Access Compliance Report Public Rights-of-Way (Curb Ramps)

Main Street: LIVINGSTON_AVE Cross Street: WESTON_PL Location: NE

ADA ID: RPRK220124122232 Ramp Type: Type 4 - Parallel Initial Pass/Fail: Fail Overall Compliance: No Severity Score: 2

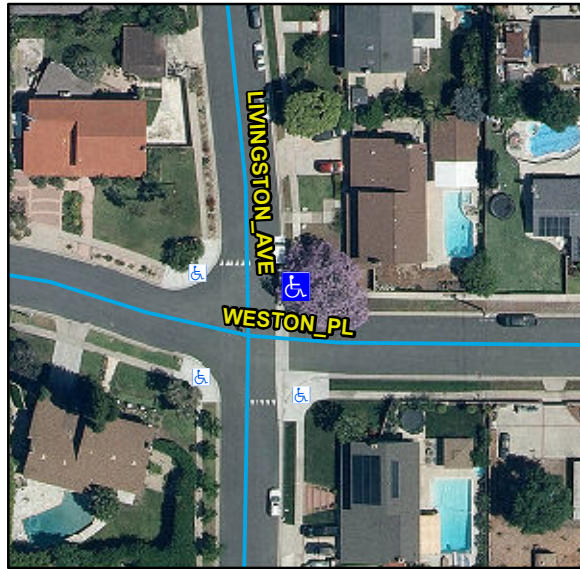
Compliance	Description	Data	Compliance	Description	Data
N/A	Ramp Length LT (in)	82	N/A	Ramp Length RT (in)	92
Yes	Ramp Width LT (in)	114	Yes	Ramp Width RT (in)	114
Yes	Ramp Run Slope LT (%)	2	Yes	Ramp Run Slope RT (%)	5.2
Yes	Ramp Cross Slope LT (%)	1.9	No	Ramp Cross Slope RT (%)	3.2
N/A	Landing Present	N/A	N/A	DWS Provided	N/A
N/A	Landing Length (in)	N/A	N/A	DWS Contrast	N/A
N/A	Landing Width (in)	N/A	N/A	DWS Length (in)	N/A
N/A	Landing Run Slope (%)	N/A	N/A	DWS Full Width	N/A
N/A	Landing Cross Slope (%)	N/A		DWS Offset Type	N/A
N/A	Landing Movement Obstructed?	N/A	N/A	DWS Offset Left (in)	N/A
	Landing Movement Type	N/A	N/A	DWS Offset Right (in)	N/A
N/A	Landing Shared	N/A			
N/A	Clear Space	Yes			
N/A	Clear Space To Crosswalk (in)	N/A			
N/A	Marked Crosswalk 1	No	N/A	Marked Crosswalk 2	No
	Crossing 1 Direction	NW		Crossing 2 Direction	S
	Marked Crosswalk 1 Width (in)	N/A		Marked Crosswalk 2 Width (in)	N/A

Remove & Replace Curb Ramp With Two New Directional Ramps or Equivalent.

R304.5.3, STD 1115
